CALL NO. 103
CONTRACT ID NO. 181025
ADDENDUM # 3

Subject: BOONE COUNTY, STP 8200(017)
Letting July 27, 2018

- (1) Revised - Proposal Bid Items - Pages 237-243 of 243
- (3) Revised - Plan Sheets - R2g, T13, T14, and T16

REVISED 7-25-18

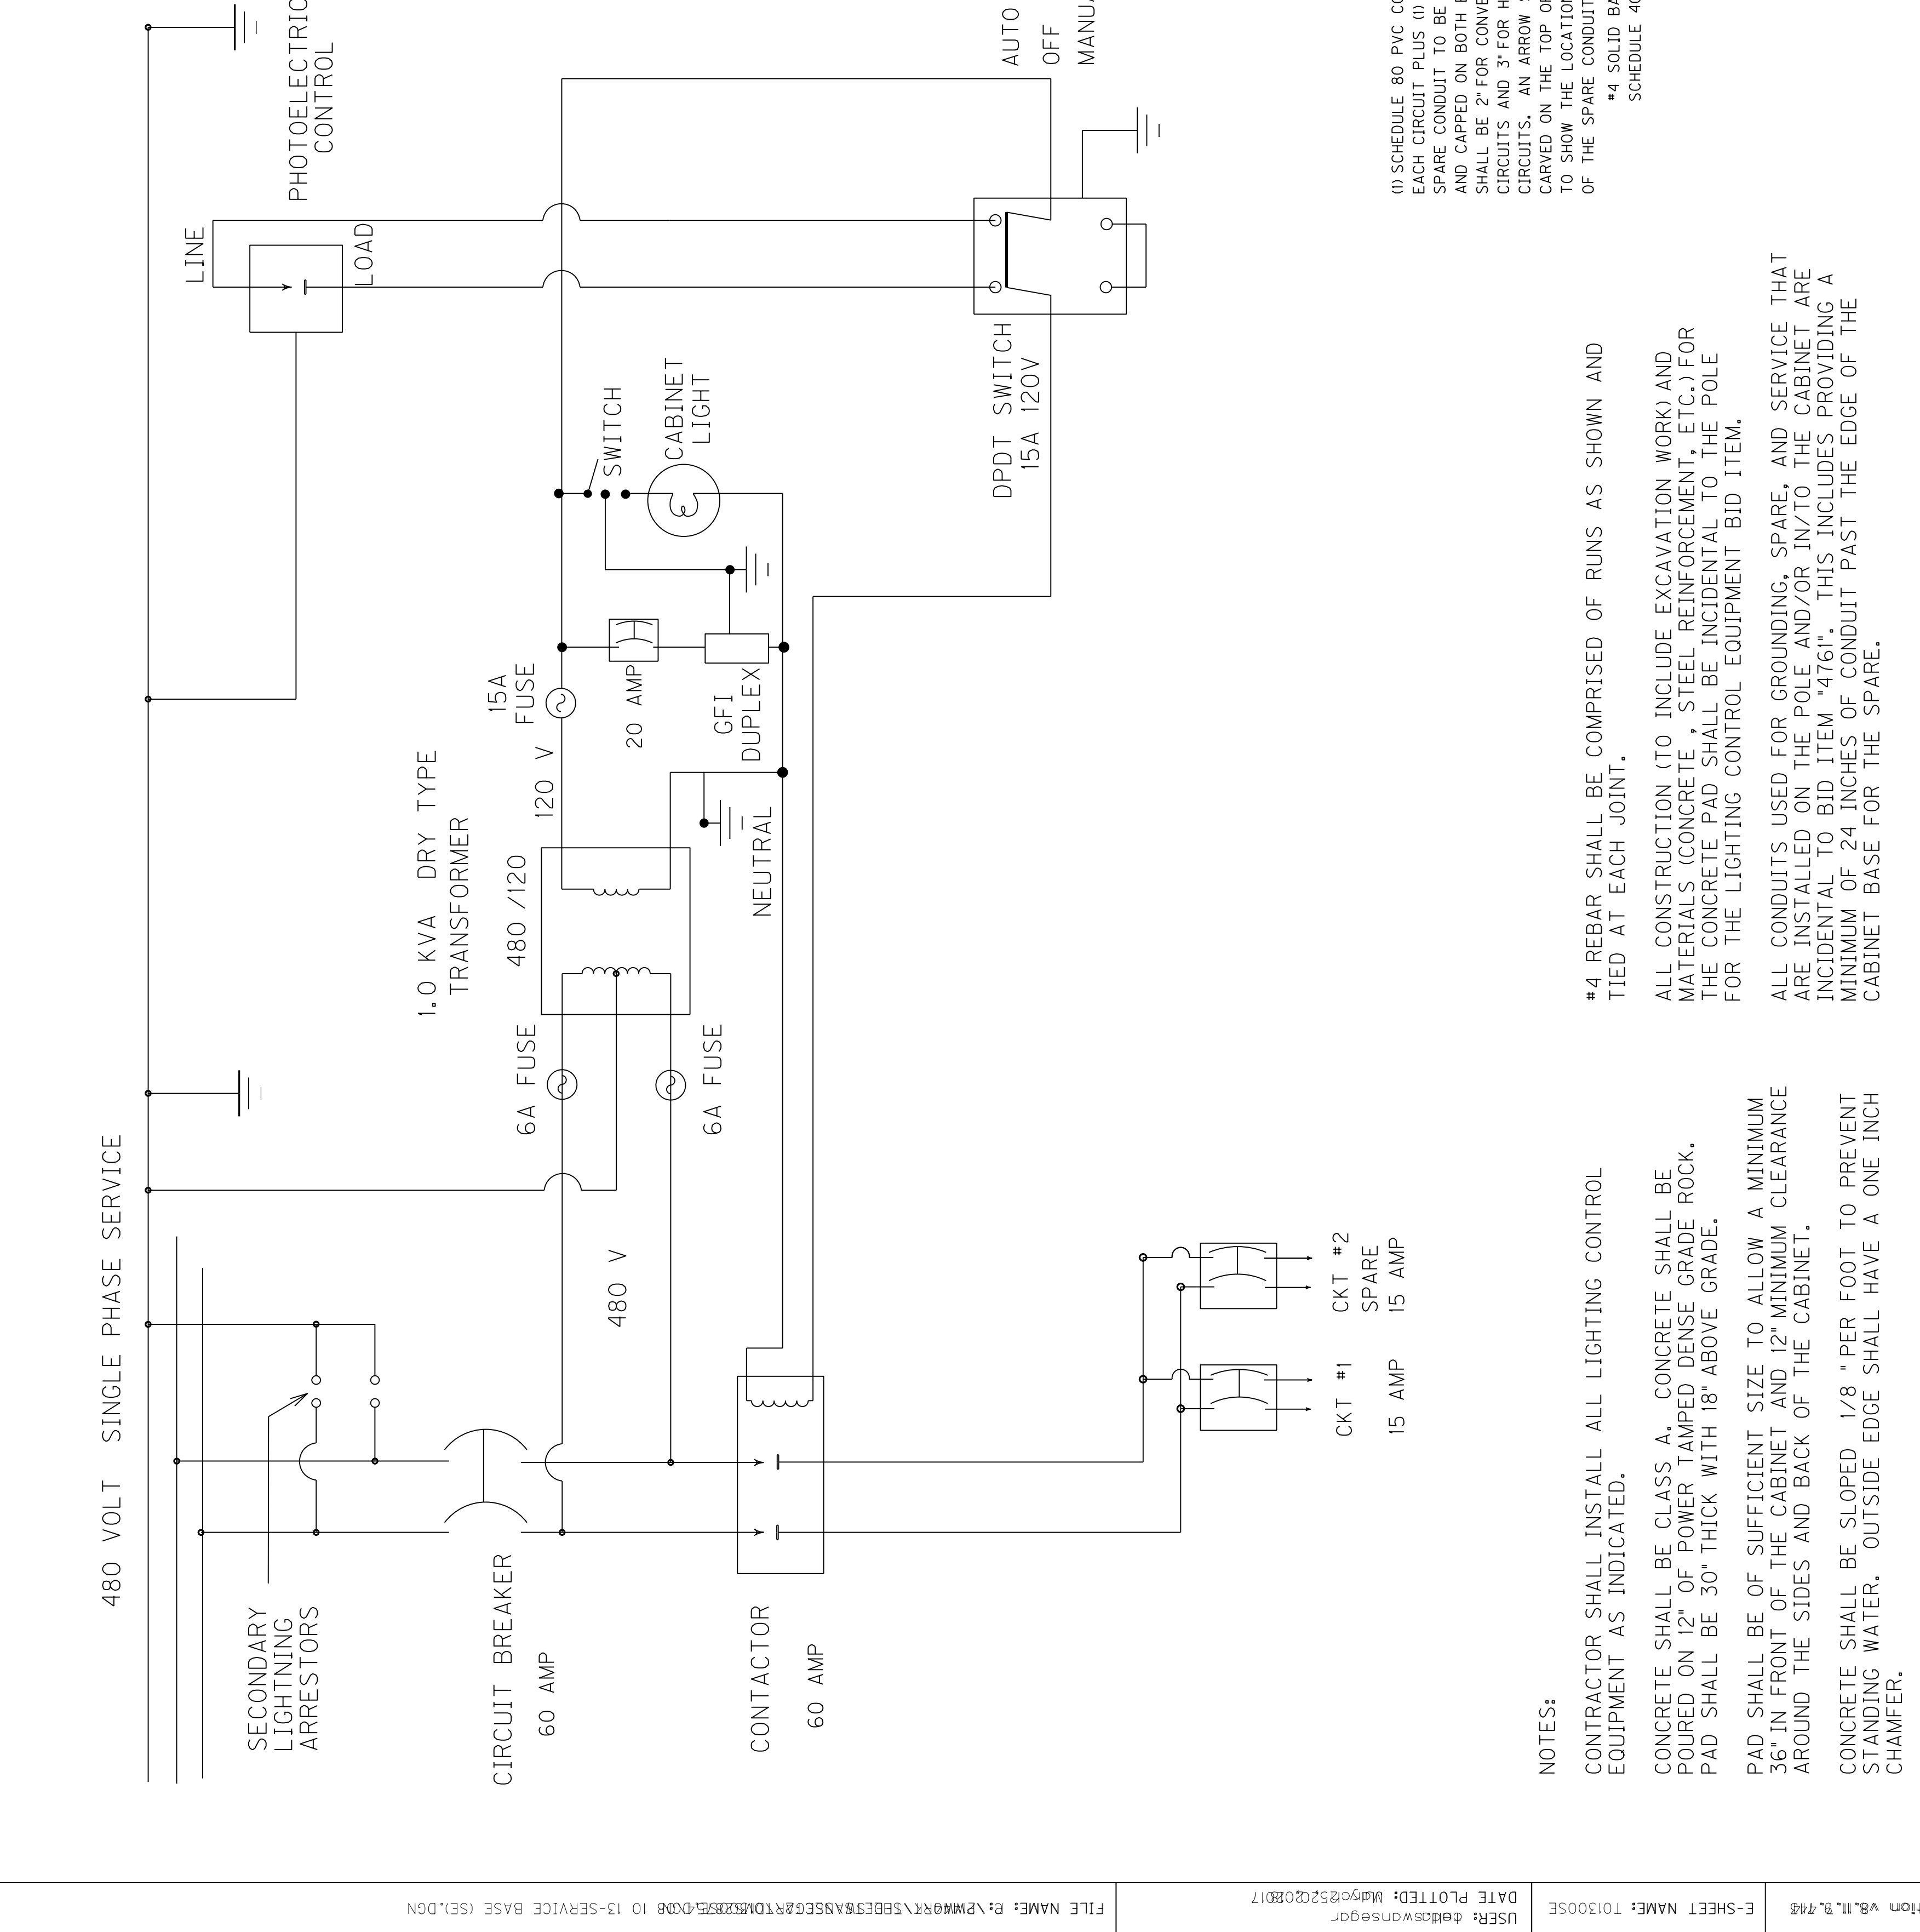
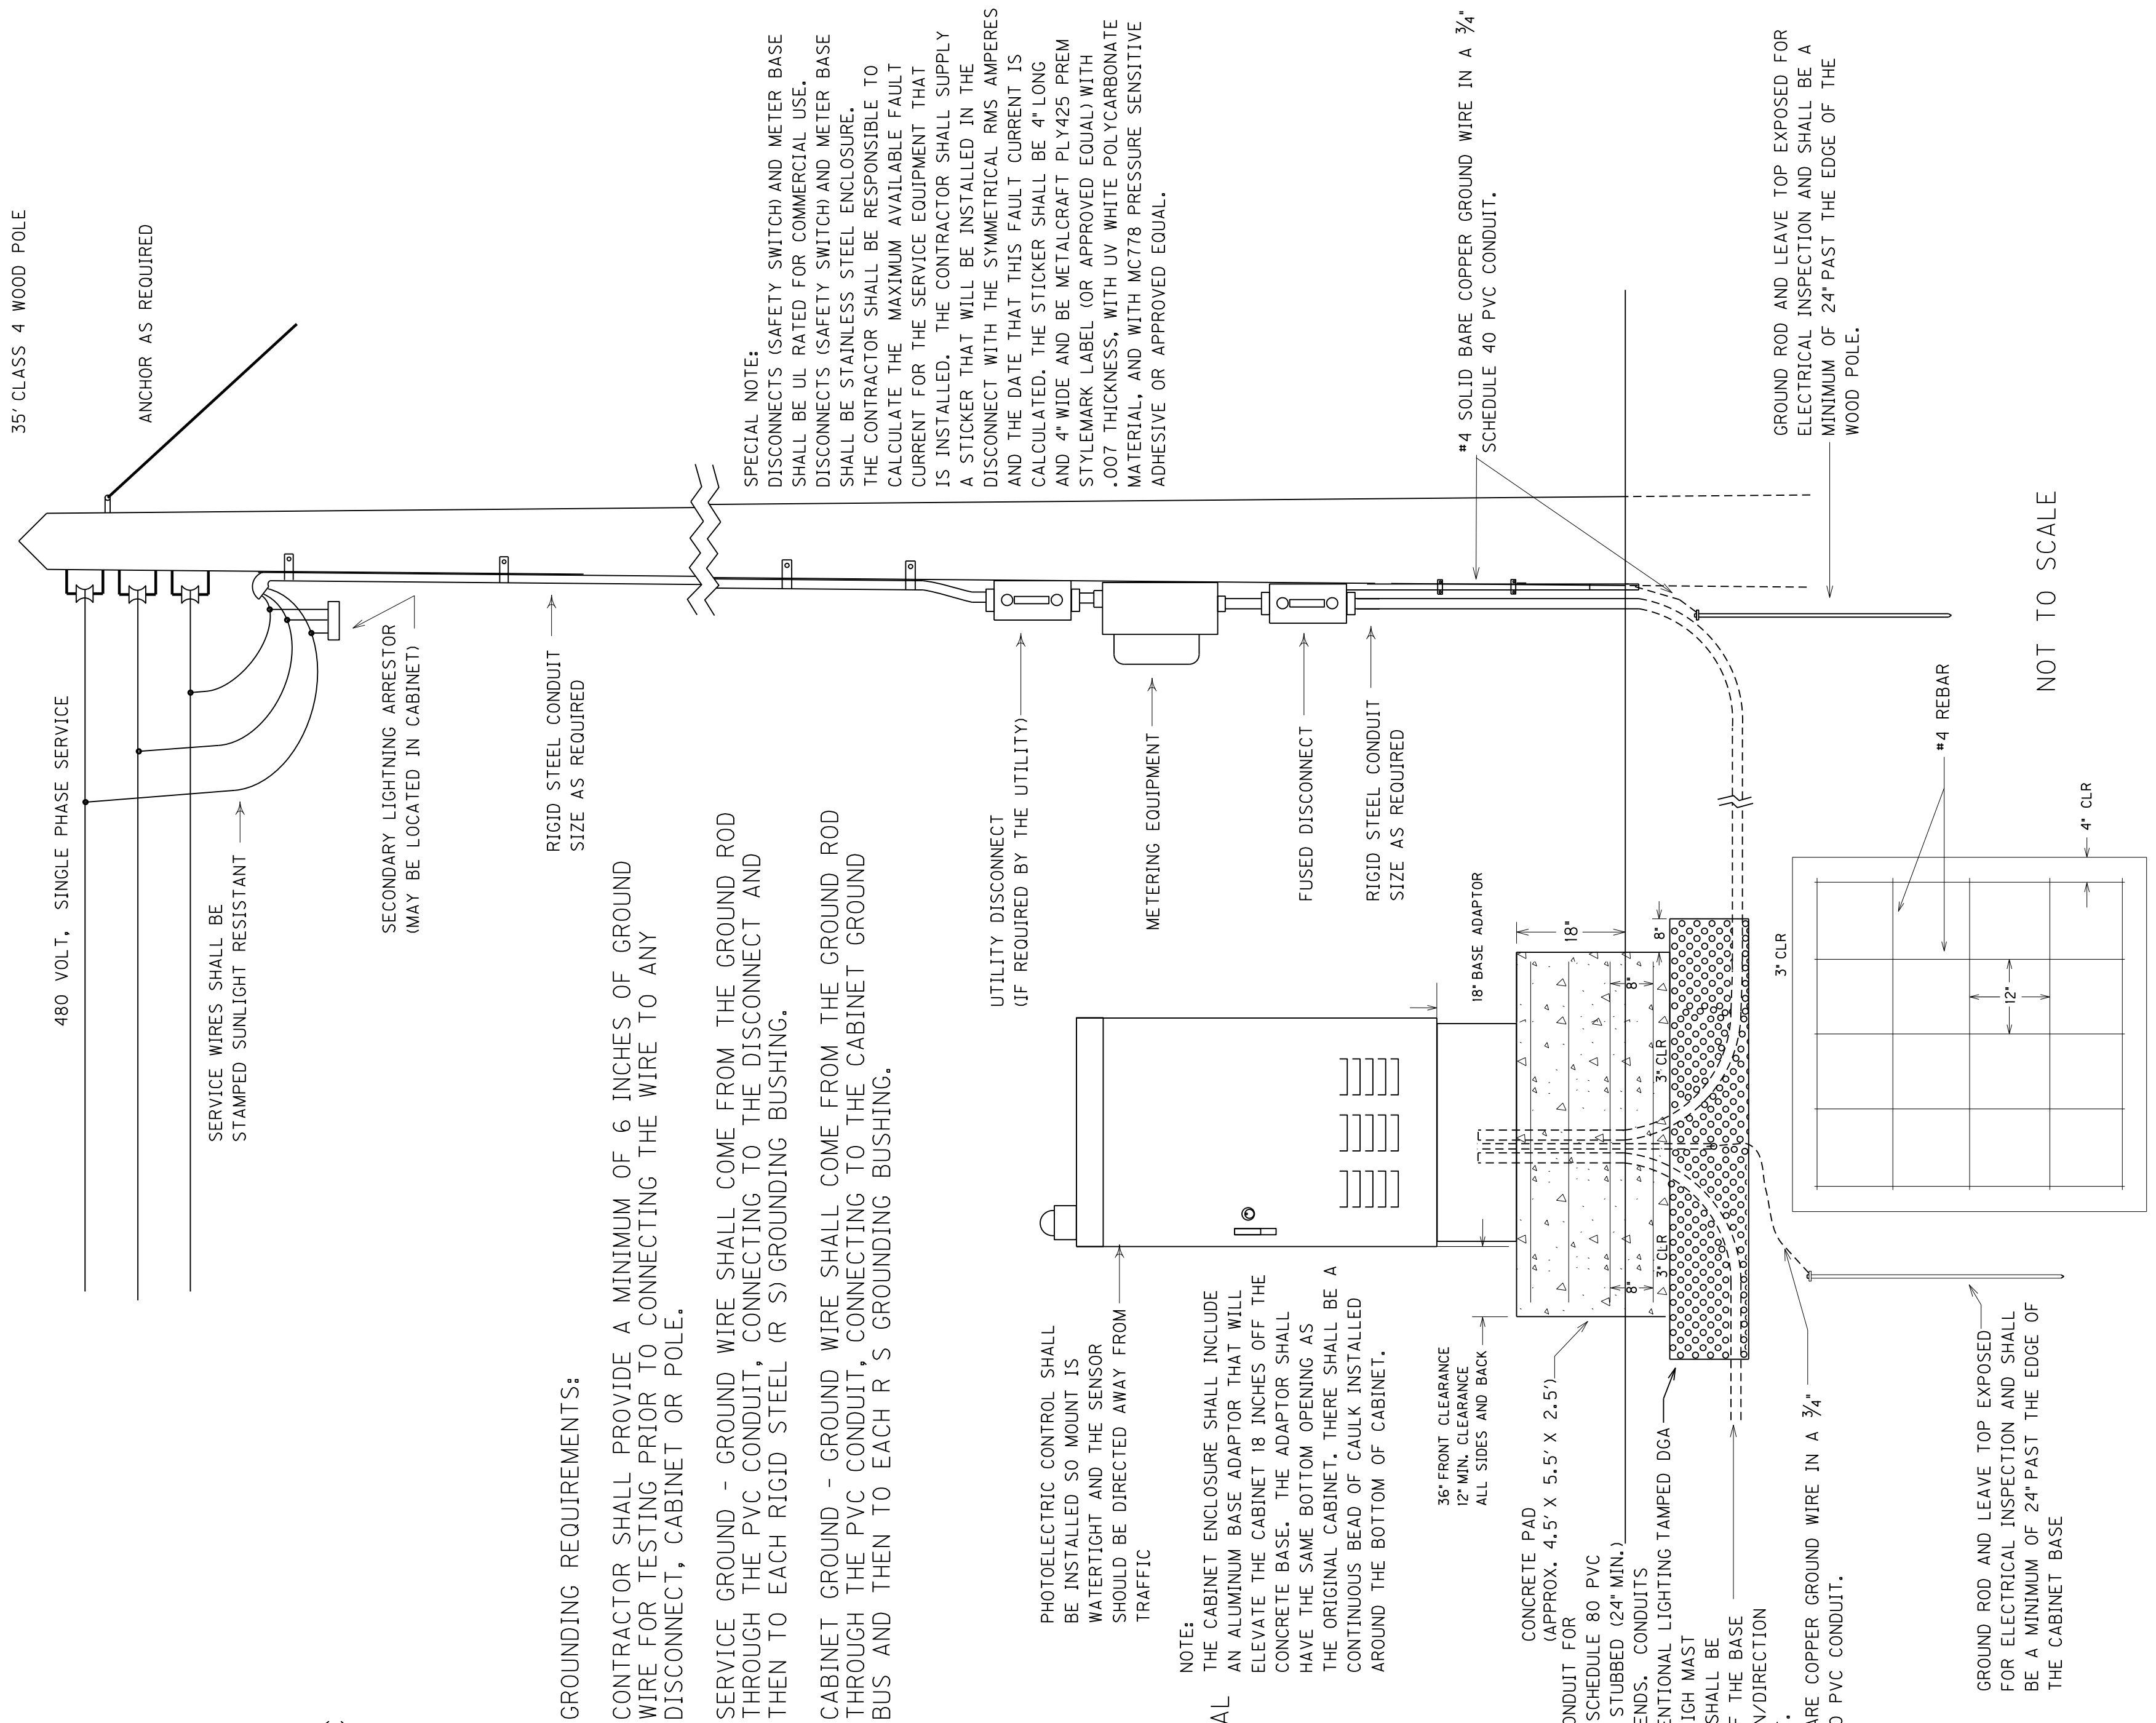
| ITEM | DESCRIPTION | UNIT | KY 237 | THUNDER RIDGE DRIVE | CARTERS MILL / OAKBROOK | CAMP ERNST ROAD | BLUE STEM EXTENSION | MOT | PROJECT TOTALS |
|------------|---|------|--------|---------------------|-------------------------|-----------------|---------------------|-------|----------------|
| 2731 | REMOVE STRUCTURE - EX. 14'X6' RCBC @ STA. 136+42 | LS | 1 | | | | | | 1 |
